Draft White Paper

**SC&A REVIEW OF ISSUES RELATED TO RECONSTRUCTION OF  
DOSES FOR WORKERS EXPOSED TO RECYCLED URANIUM AT  
FERNALD – A SECOND WHITE PAPER**

February 2011

**Figure 1. Normal Score Plot of Plutonium in Batches of Uranyl Nitrate Hexahydrate from Hanford (1970–1972)**

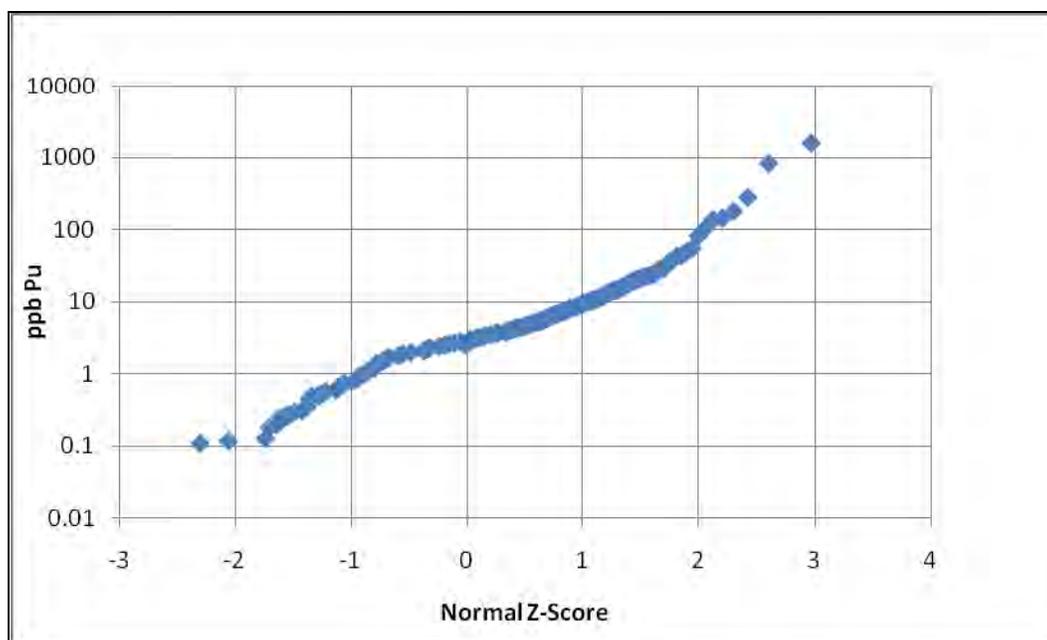
Figure 1 is a normal score plot for the plutonium data. Figure 1 indicates that the data seem to fit a log-normal fairly well up to the 95<sup>th</sup> percentile (about 2 z-scores). The 7 high values in the upper tail (> 100 ppb) are limited to just six batches (batches 3-1 to 3-4 on April 9 and 10, 1971; batches 2-20 and 2-21 on December 2 to 3, 1971; and batch 2-65 on January 6, 1972). The relatively frequent occurrence of plutonium out of specification (greater than 10 ppb) raises the question of how often highly contaminated batches were processed and/or shipped and whether Fernald personnel were aware of them.

**Figure 2. Normal Score Plot of Np-237 in Batches of Uranyl Nitrate Hexahydrate from Hanford (1970–1972)**

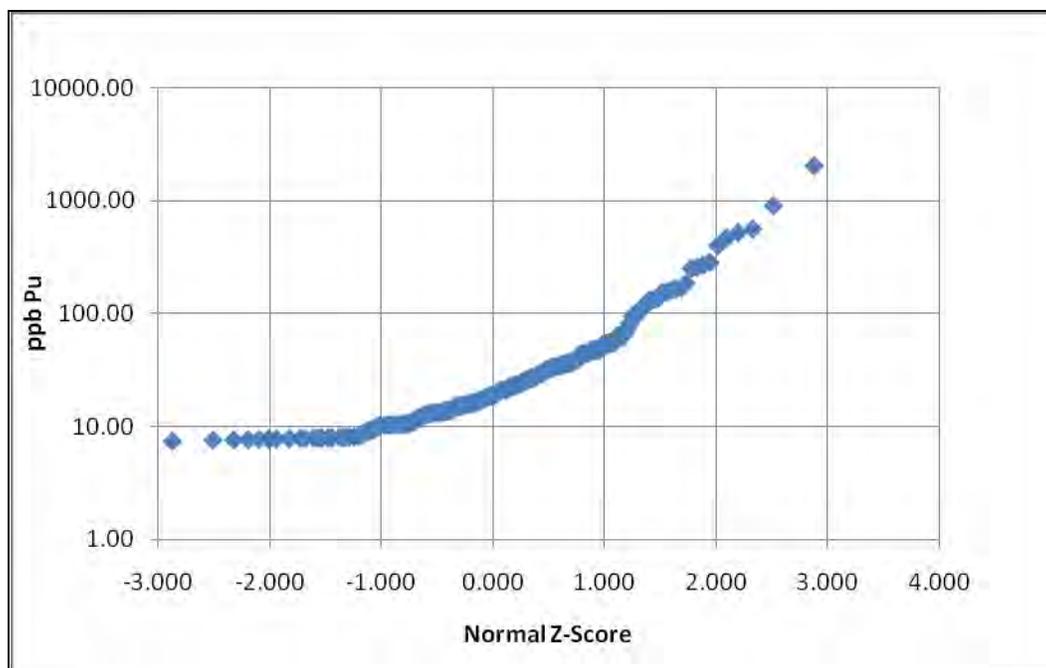
Figure 2 indicates that the data seem to fit a lognormal fairly well within  $\pm 1$  z-score, but about 13% (32/252) are near the LOD and about 10% (38) are much higher than predicted by the lognormal. As was true for the Pu data, the highest values came from about 6 batches. Based on a hypothetical "lower bound" efficiency of 1, values >LOD range from about 7 to 2,040 ppb U, with an arithmetic mean of 53 with a SD of 155. For values within the lognormal range, the GM and GSD are 24 and 2.6. Given the high outliers, a GSD of about 5 might be more appropriate.

**Figure A3-1: Entire Site (With Titan), Pu-239/240**

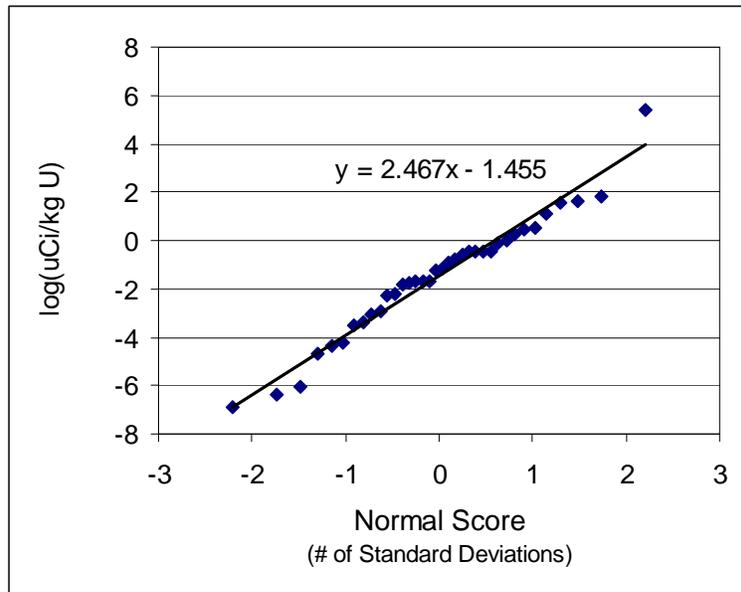
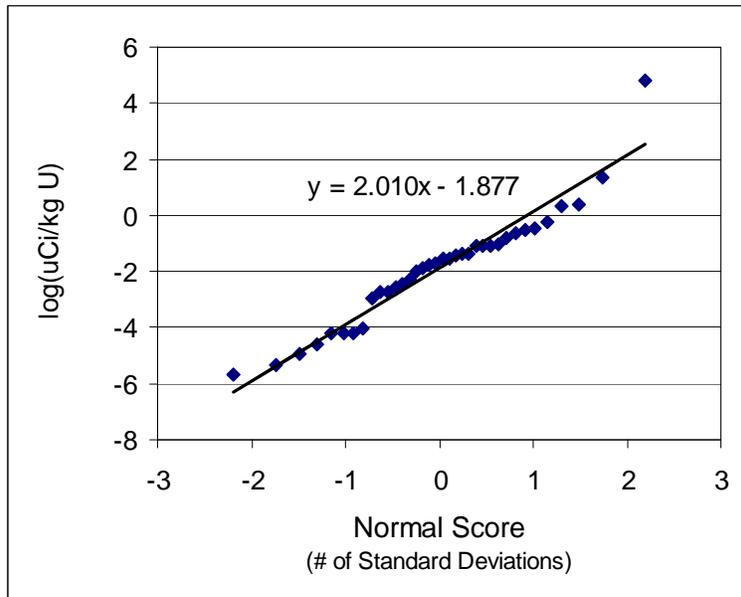
To better understand the distributions of contaminant levels in the RU plants represented by the dust data, SC&A performed a statistical evaluation of the data for Pu-239, Np-237, Tc-99, and Sr-90. A set of normal score plots in Figures A3-1 through A3-32 of Attachment 3 show that the lognormal distribution fits the dust ratios fairly well, despite the limited sample sizes. The Titan data are the clear outlier in Figures A3-1 and A3-2 for Pu-239 and Np-237, respectively. For
